Attachment I

**Effects of changing height of Cape's Dam on recreation, Texas wild
rice and fountain darter habitat in the San Marcos River, Texas**

**Watershed Systems Group, INC
San Marcos, Texas**

October 12, 2015

Figure 1. San Marcos River study area.

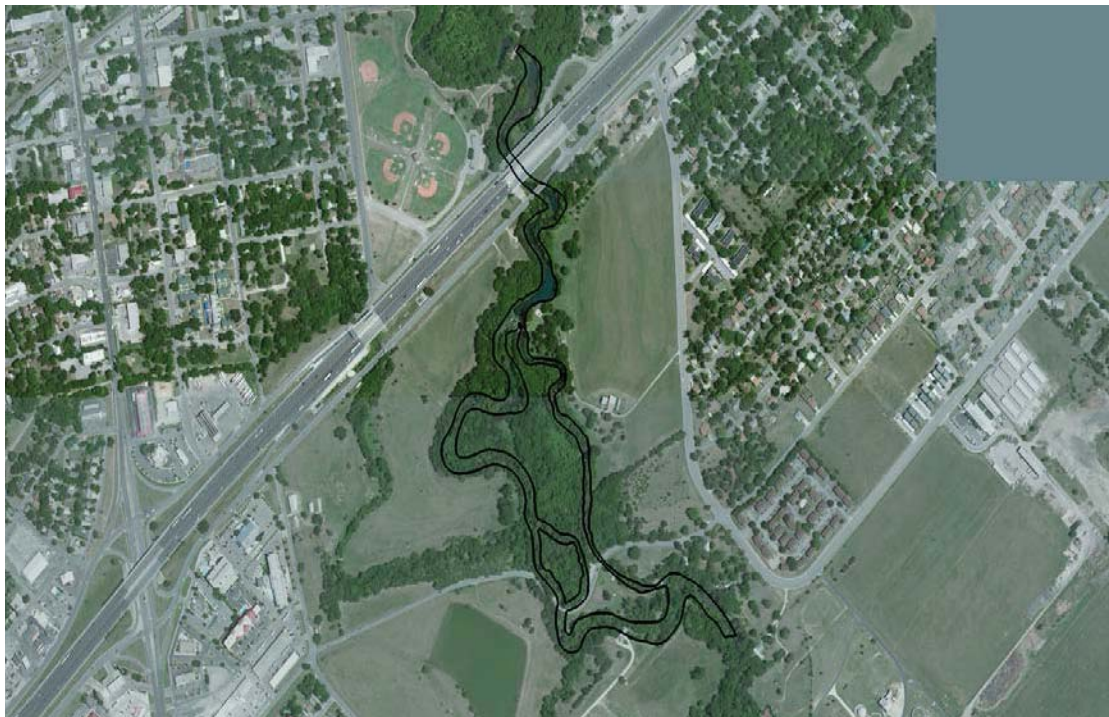
Neither Rio Vista Dam, nor the TPWD Fish Hatchery are included in the limited aerial extent of Fig 1: "Study Area." Furthermore a reader must know the San Marcos River at 1-35 well enough to know where Fig 1 "Study Area" is located and recognize that neither Rio Vista Dam nor the Fish Hatchery are located within the "Study Area" as depicted in Fig 1.

Where is the "Empirical data" that shows the effects of Capes Dam does not extend far enough to reach Rio Vista Dam?

"...therefore the section of the river between Rio Vista Dam and the upstream extent of the model is not included in this study." is a direct contradiction of the 2nd sentence of the same paragraph. Which statement is a reader to believe?

WHERE is Capes Dam - the very subject of the report - located? Readers of this report are never informed.

Figure 2. Spatial location of Texas wild rice above and below Cape’s Dam in the San Marcos River.

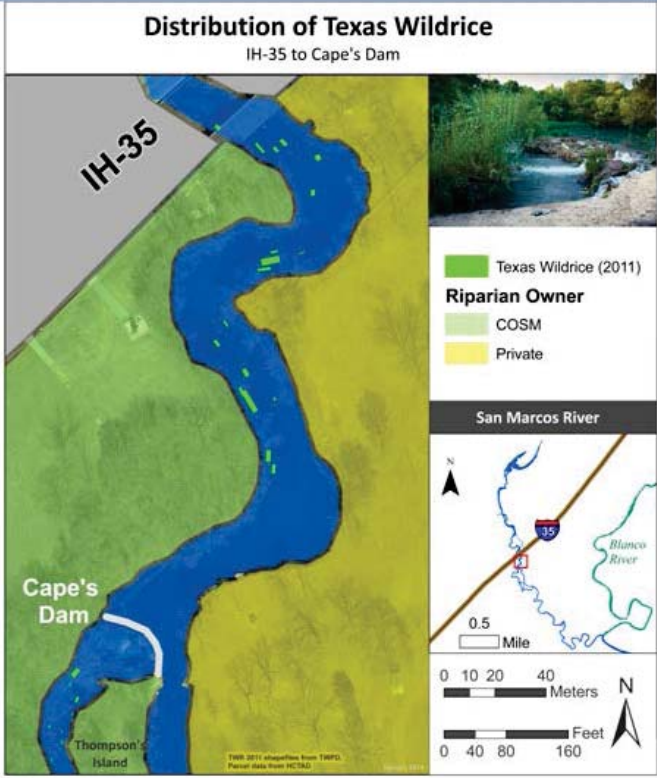
Figure 2 of this Oct 12, 2015 report from Watershed Systems Group is the ONLY figure in which the location of Capes Dam is revealed.

NOTE: Capes Dam is the very *subject* of study of *both* this report and the June 24, 2015 report, so omissions from ALL figures save this Figure 2 to record the location of Capes Dam is a serious failure of professionalism from a private research company resting on the laurels and reputation of the reports two authors.

Figure 3. Example of field measured topography points (A) and computational mesh mapped onto elevation contours (B) and substrate (C).

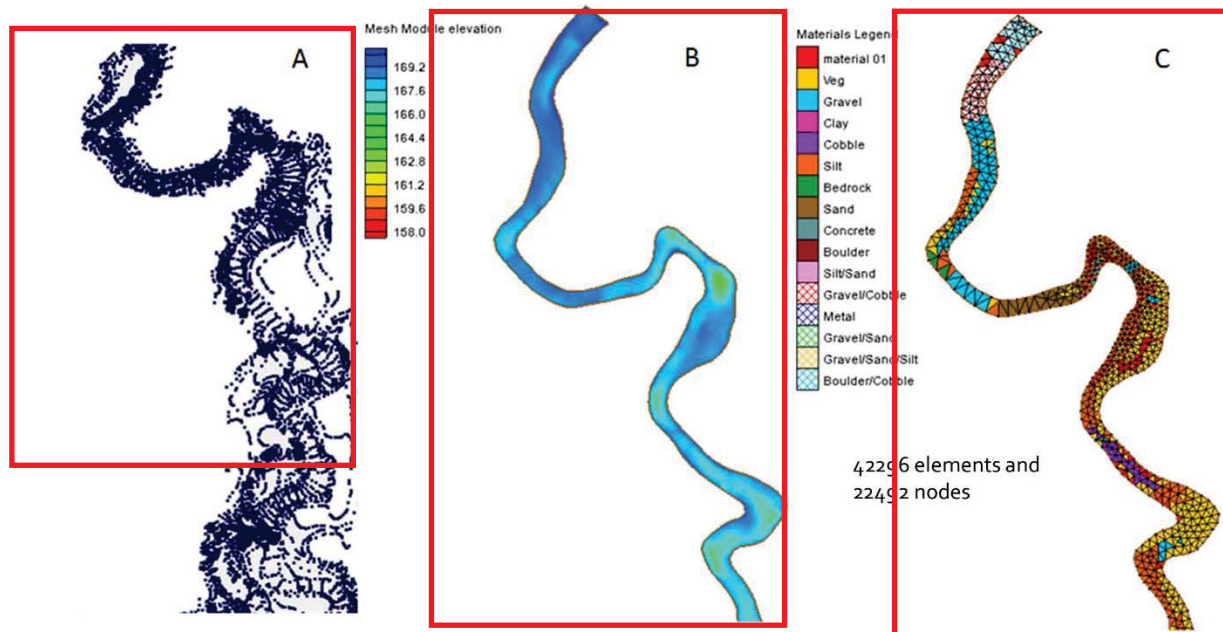
These 3 depictions do not cover the same aerial extent and yet no where is the reader informed of this important change of scale. This Figure is repeated from June 24, 2015 version of study.

Figure 5. Assumed computation mesh for full height Cape's Dam used in the hydrodynamic modeling.

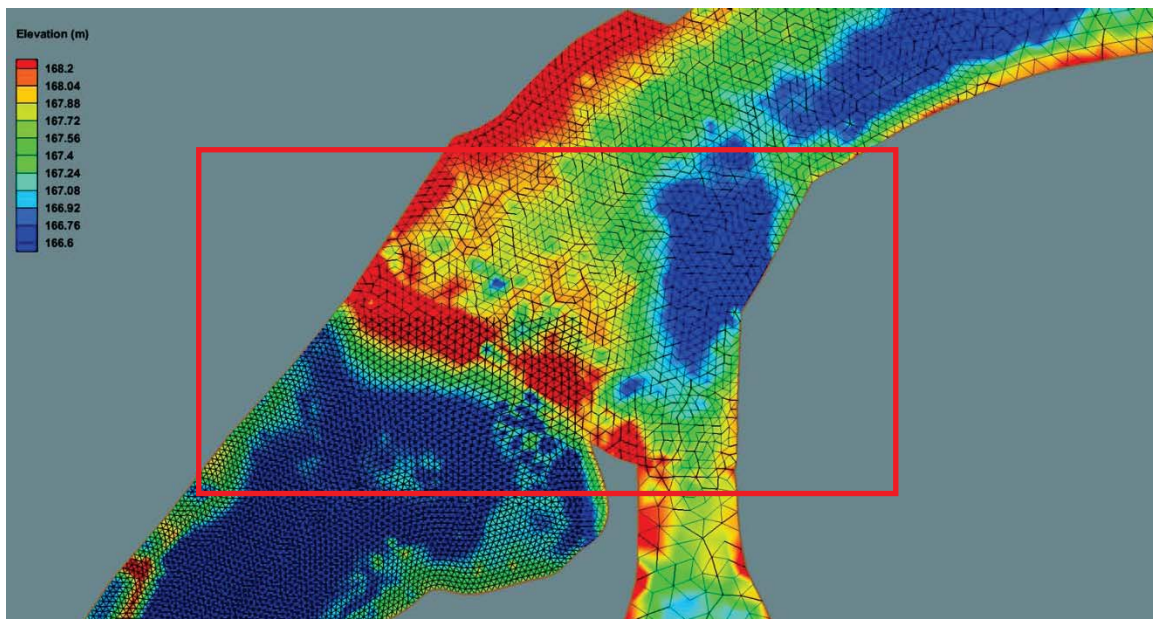
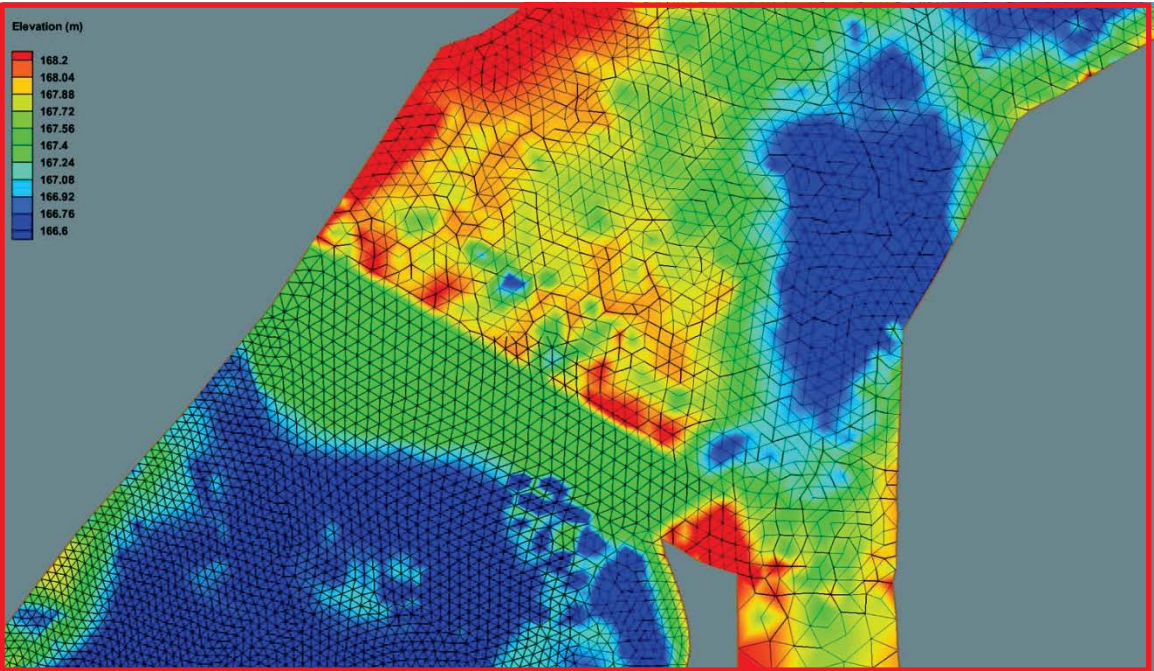
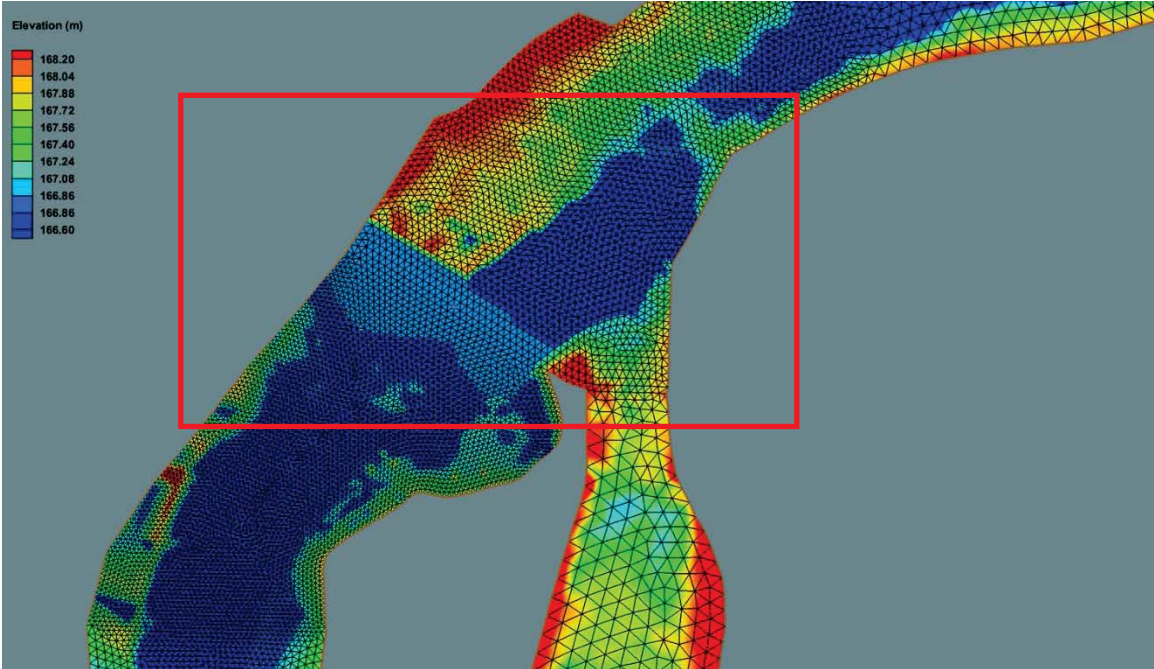
Red box indicates approximate outline of area shown in Figures 6 and 7. According to basic science protocols, when making a comparison, the scale of the diagram and the aerial extent of the 3 comparisons should be identical; Figures 5 through 7 show different areas, at different scales, rendering the purported comparison between Fig 5 thru 7 meaningless.

Red box indicates approximate outline of area shown in Figures 5 thru 7.

Figures 5 through 7 purport to show the effects of changing Capes Dam's heights, and yet the scale and area of the San Marcos River is different in each of the 3 diagrams. This is *not* only not science, this is highly unethical slanting of the visual display by tricking the reader into thinking they are looking at observable changes that are only the effect of changing the scale and aerial extent of the photo.

Figure 8. Location of field measurements of sediment cross-sections behind Cape's Dam and interpolated spatial distribution used in hydrodynamic modeling (adapted from Hudson 2012).

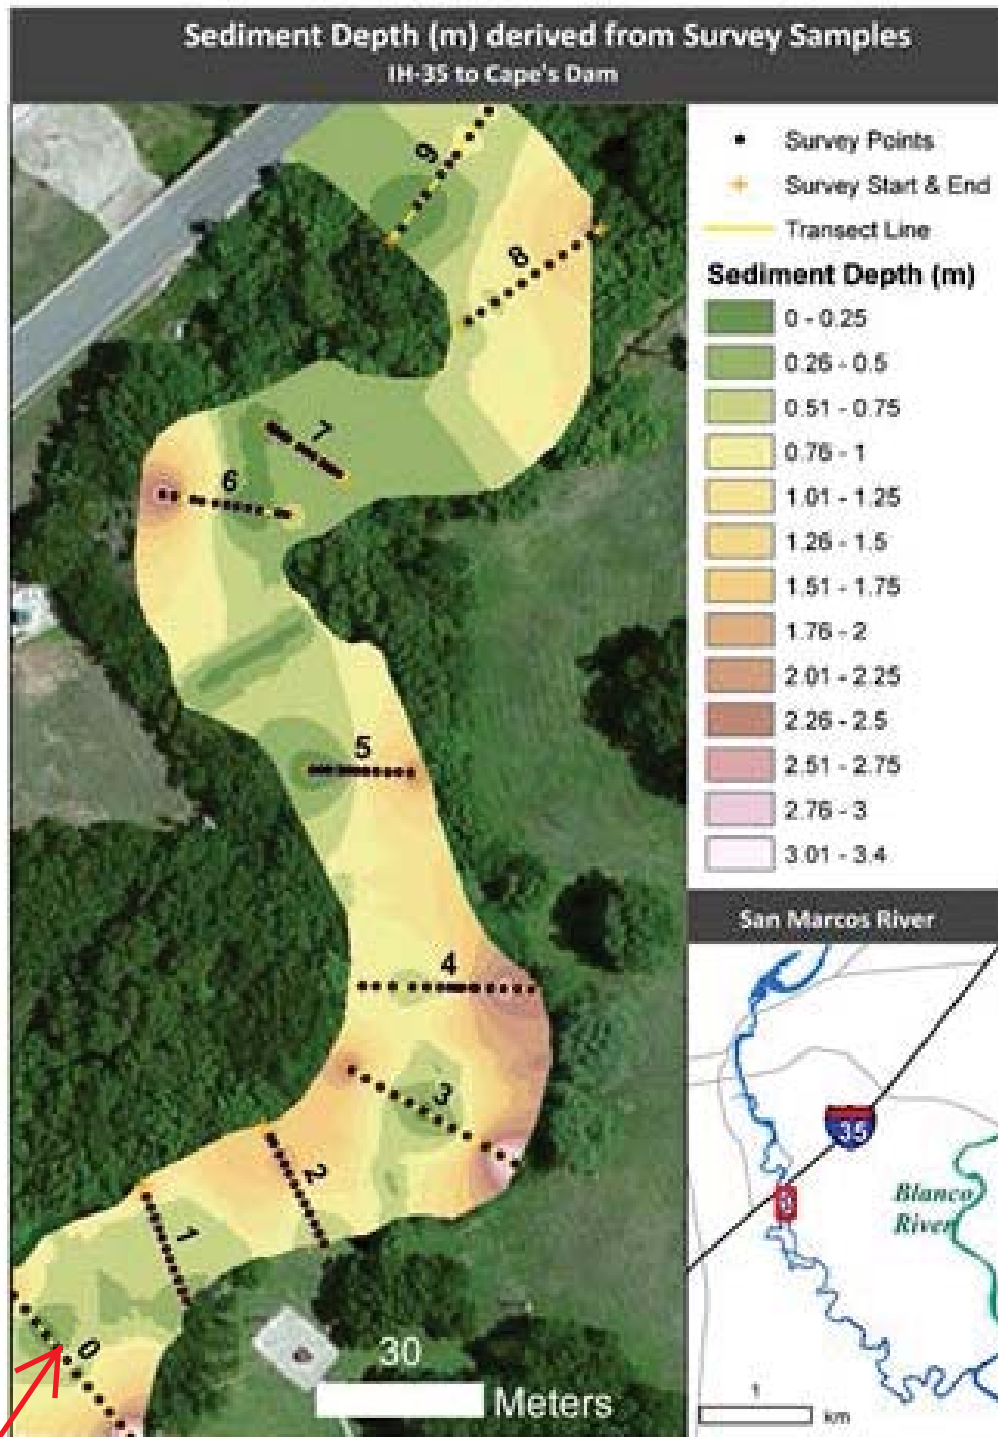
Where is Capes Dam in Figure 8 (below) and why is Capes Dam NOT shown?

NOTE: This diagram shows that less than 0.25 meter (> 1 ft) of sediment is located behind Capes Dam - represented by a straight line (Capes Dam is not a straight line dam, but quite curvilinear) marked as "0" in this diagram, which once again, does not disclose the location of the very subject of this report - Capes Dam. This type of omission from a "scientist" shows low quality work that is typical through-out both "gray" literature reports published by Drs Hardy & Raphelt and sold to the City of San Marcos.

Figure 9. Sediment depth profiles for selection cross sections (XS numbers correspond to cross-section locations in Figure 8) behind Cape's Dam (adapted from Hudson 2012). The difference between the water depth and sediment depth lines represent the depth of accumulated sediment.

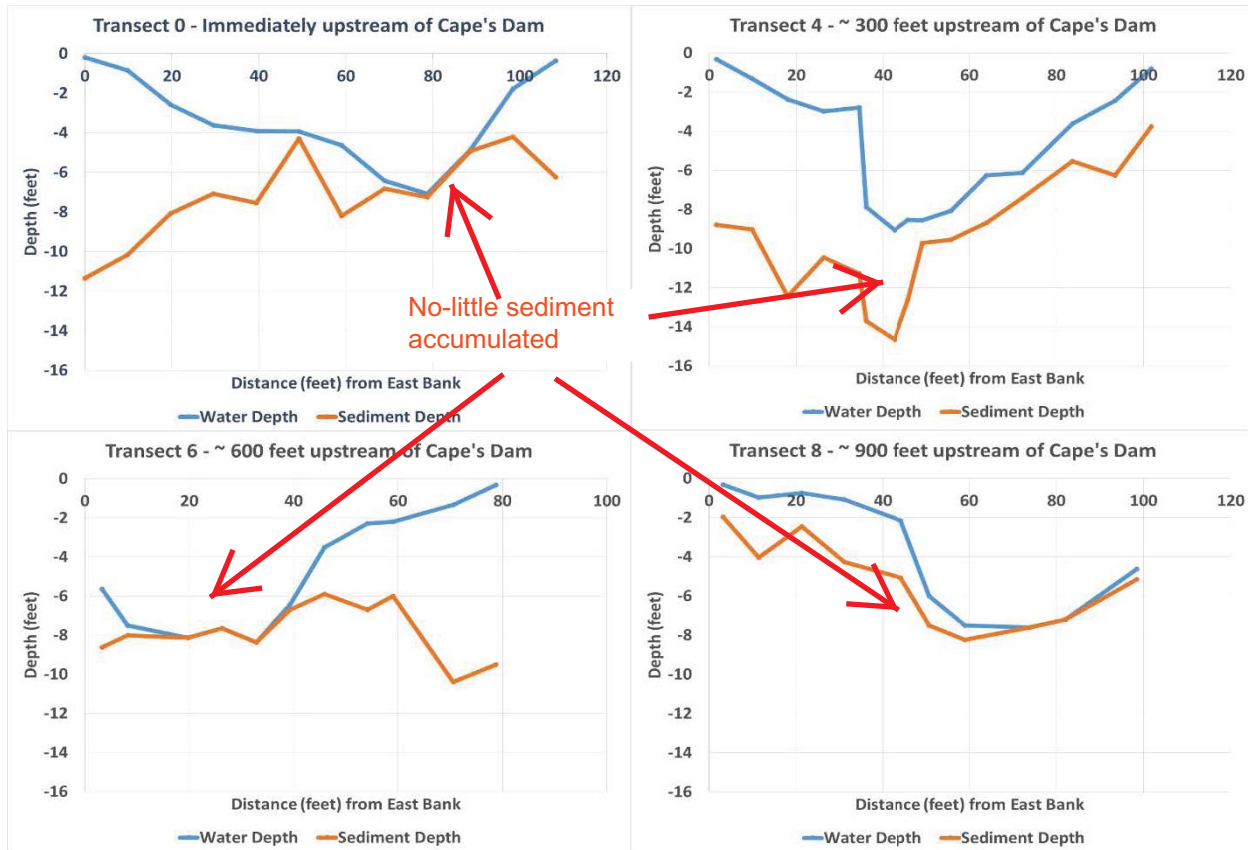
Figure 9 shows that the deepest sediment accumulation in the river is not in the thalweg (the deepest part of the channel) but is off to the sides of the main channel. So how is removing Capes Dam, which is going to increase water flow in a narrow-restricted, deepest part of the river channel, going to "flush out" and provide the "expected sediment transport" -- when the sediment is shown to be in the **banks of the main channel** -- not the main channel (thalweg) where water will flow once

Figure 12. San Marcos River depth with full height, half height, and full Cape’s Dam removal at 45 cfs (approximately the lowest single observed daily flow during the drought of record).

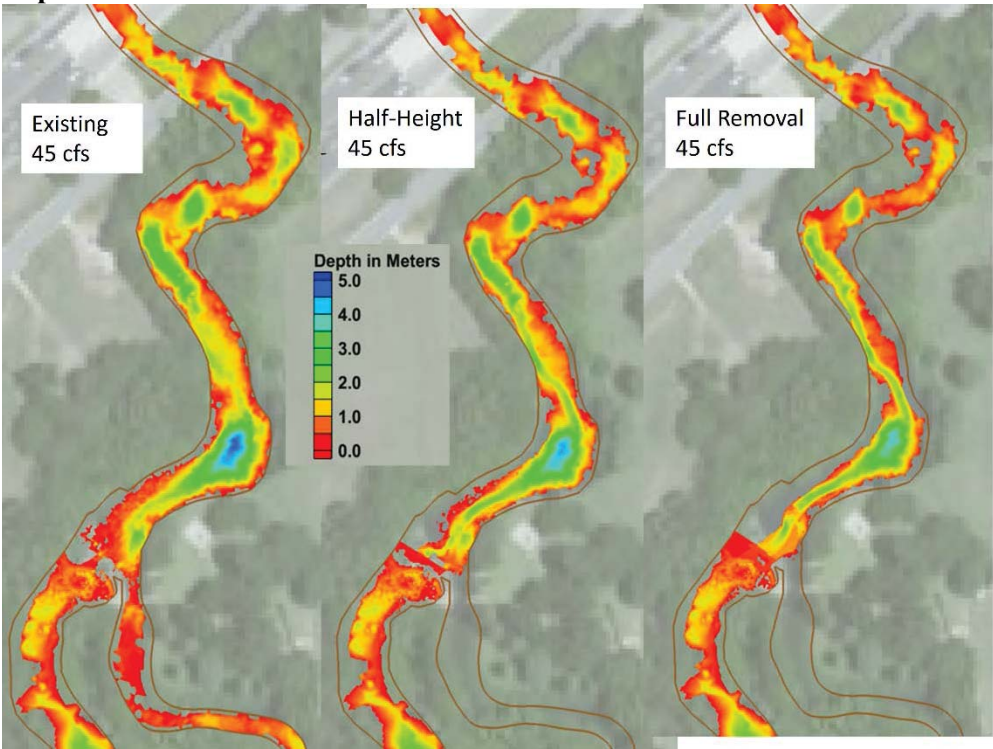
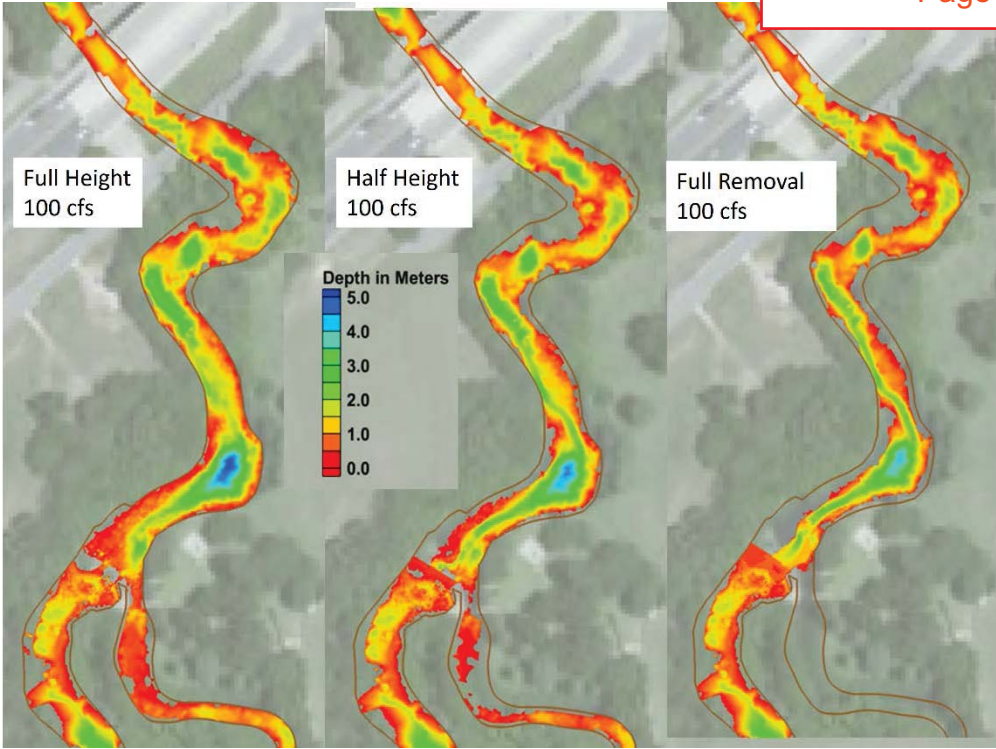
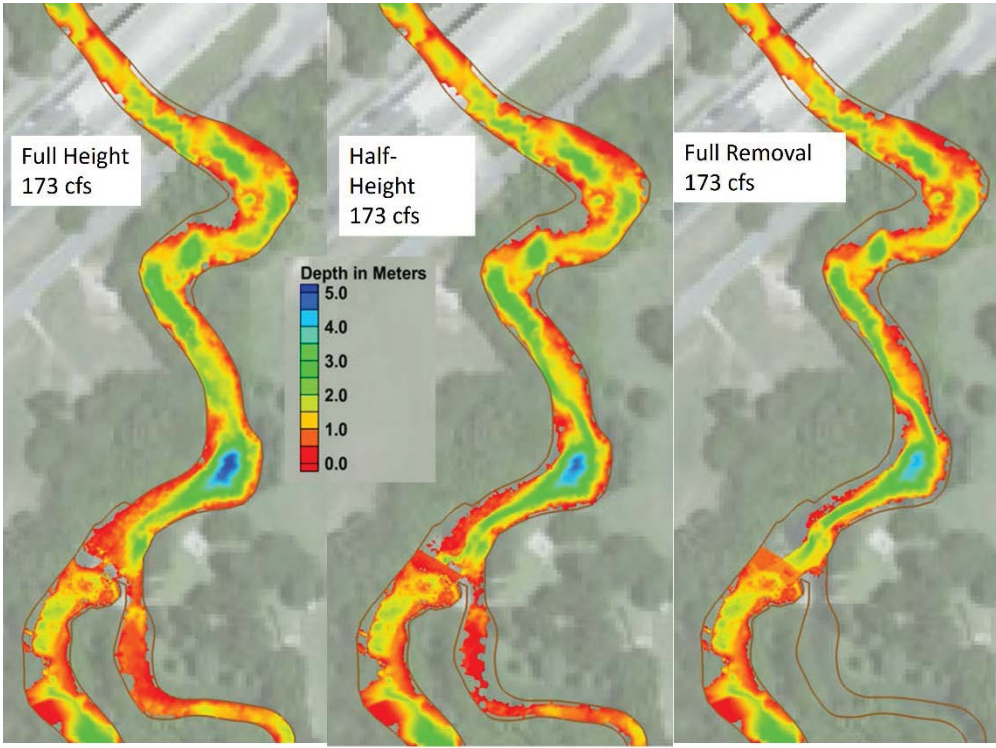
"A careful examination of the depths just downstream of IH-35 (very top of figures) show there is essentially no change in depth between any of the three scenarios at any of the flow rates..." is simply **NOT A TRUE STATEMENT**. **Empirical Evidence**, in the form of a newspaper article, attached at the end of this report, from Jan 7, 2000, clearly states, "**The breach [of Capes Dam] lowered the river level all the way up stream to Rio Vista Dam.**"
